ATTACHMENT 3

CALCULATION OF TIME TO CORE UNCOVERY FOR LOSS OF ALL AC POWER EVENT

The purpose of this letter report is to document analysis performed as part of Section 3 of the Millstone Probabilistic Risk Assessment Analysis.

FIGURE 1 SCHEMATIC OF SIGNIFICANT SEAL LEAK PATHS PER PUMP (REF. 1)

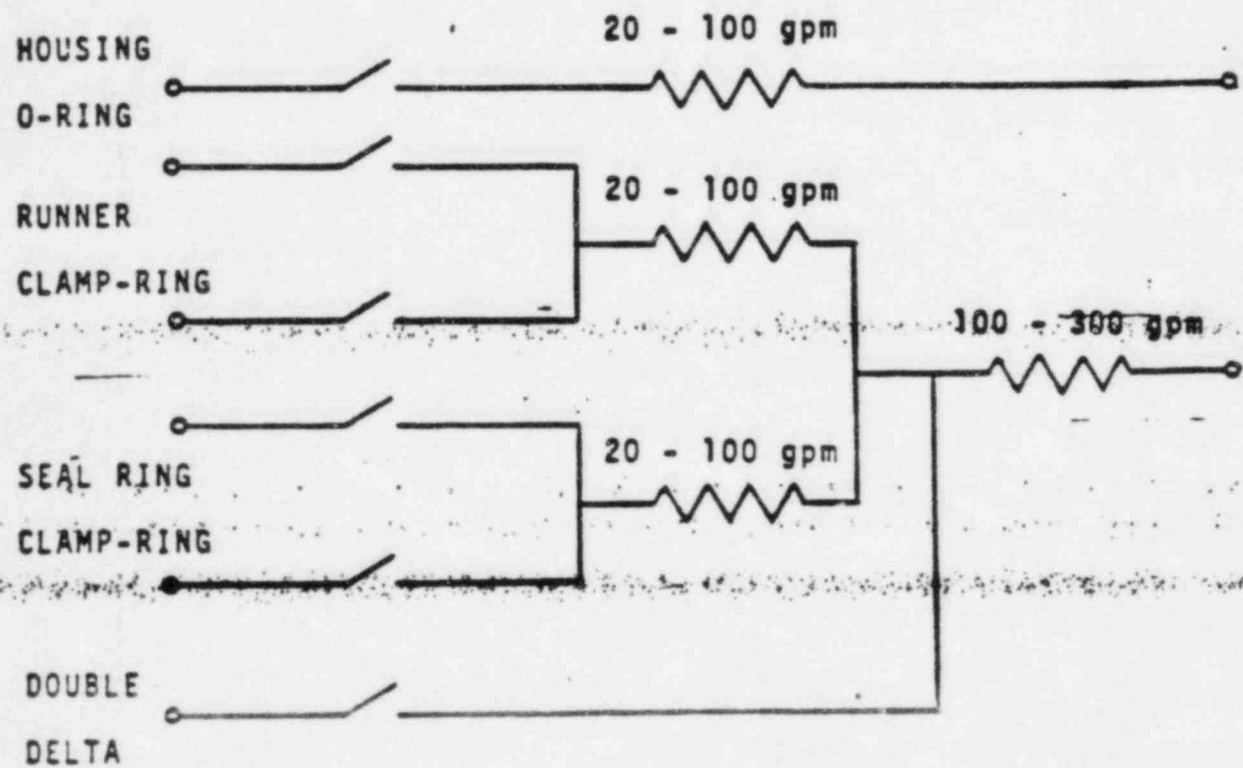
Each Millstone RCP (Model 93A) has 10 O-rings with 4 of these 10 providing only negligible leakage paths upon failure. The remaining 6 O-ring seals upon failure can allow leakage of 20 to 300 gpm at 2235 psig. A representation of these 6 seal leakage paths from Ref. 1 is given in Figure 1. A maximum RCP leakage rate of 300 gpm at 2235 psig is given by Ref. 1 as an upper bound. As seen in Figure 1, the leakage resulting from certain seal failure is limited by downstream resistances.

FIGURE 2 SIMPLIFIED SCHEMATIC OF SIGNIFICANT SEAL LEAK PATHS PER PUMP

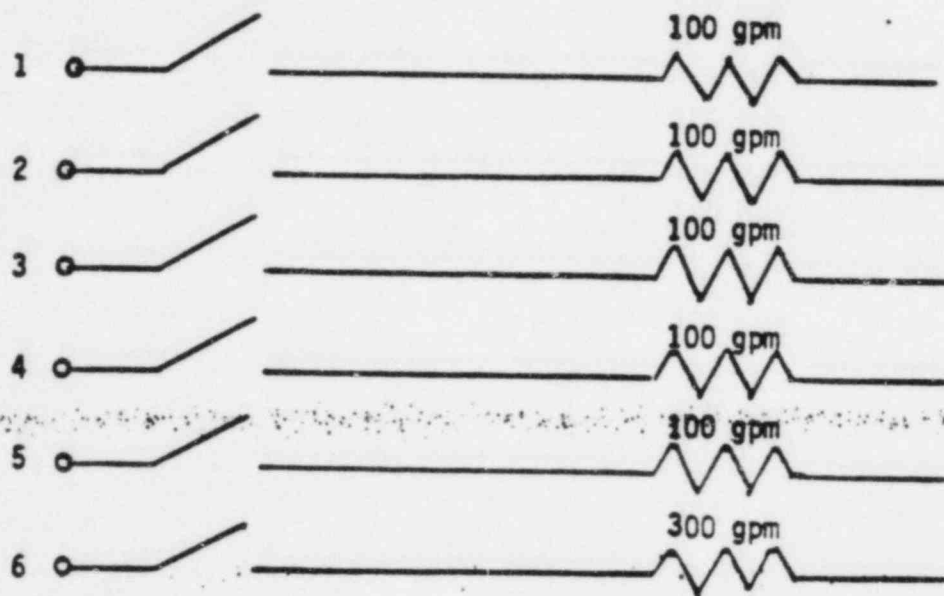
To simplify the calculation of the magnitude of leakage resulting from seal failures, the coupling effect of downstream resistances can be ignored as shown in Figure 2. This artificial decoupling of leakage paths has the effect of overestimating maximum leakage for multiple seal failures but in addition allows leakage due to individual O-ring failures to be calculated independent of other O-ring failure. An additional simplifying assumption which will be made is that upon O-ring failure, the leakage resulting from the failure is the maximum potential leakage of 100 or 300 gpm as shown in Figure 2. A 60 gpm (15 gpm/pump @ 2235 psig) nominal leakage is assumed to be present regardless of additional leakage.
